ACPE functionality outside AEBS ODD

**UK Proposed new test procedure
(Based on ACPE-04-04)**

ACPE functionality within AEBS ODD

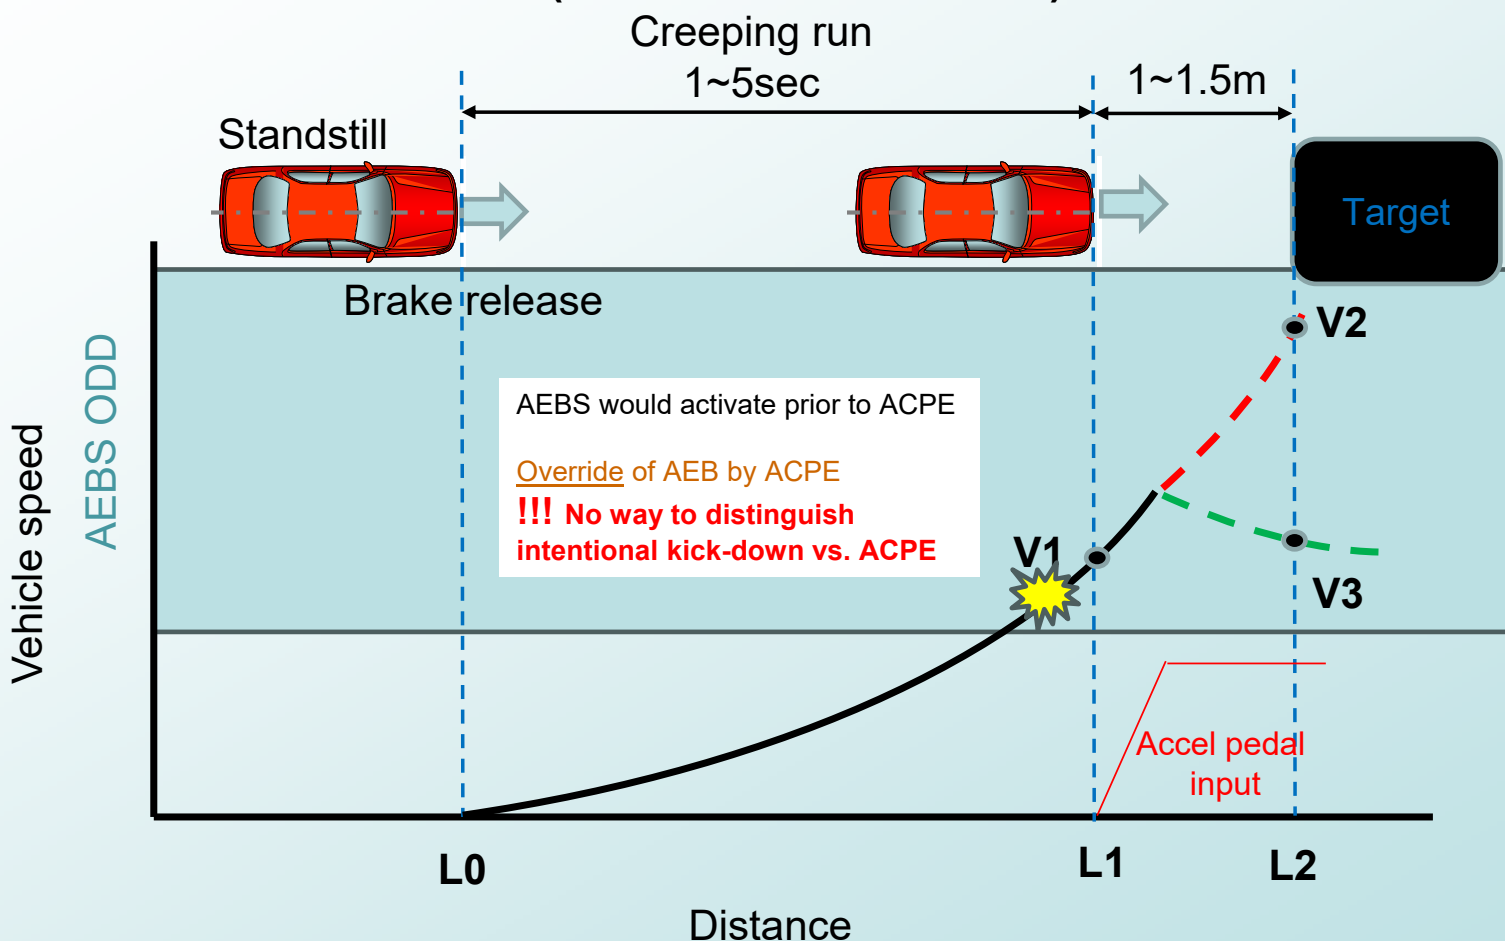
Problem:

Creeping speed could increase to above 10 km/h before impact or even before pedal misappl. => Conflict with AEBS possible
